## TELEVISION TECHNICAL BULLETIN

**MODELS**      66FW53H                      66FW54H                      76FW53H                      76FW54H

**SYMPTOM**    NVM corruption.

Reference UK003400X

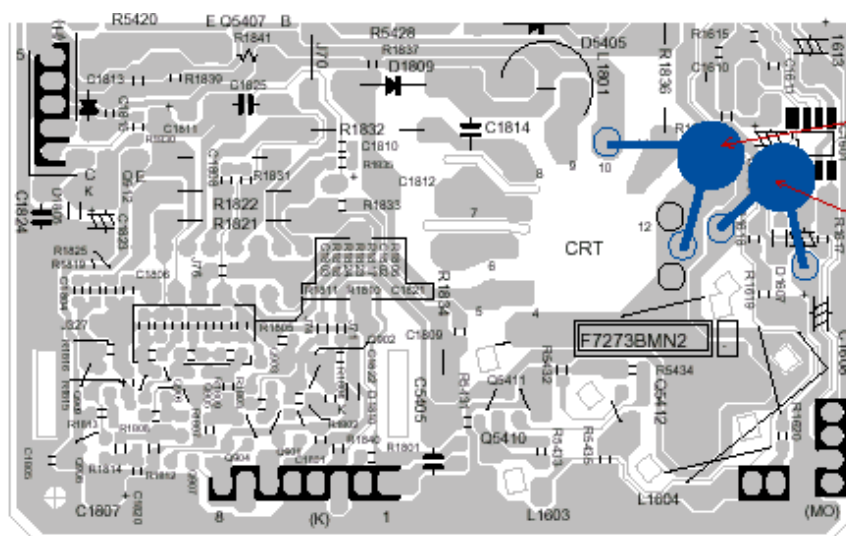
**CAUSE**        Arcing can occur on the CRT base panel (PWB-B) caused by CRT discharges.

**ACTION**        Add capacitors C1826 and C1827 as shown in the picture below.

**C1827: Pin 10&12  
CRT Socket.**

**C1826: Q5405 &  
Q5411 collectors  
track.**
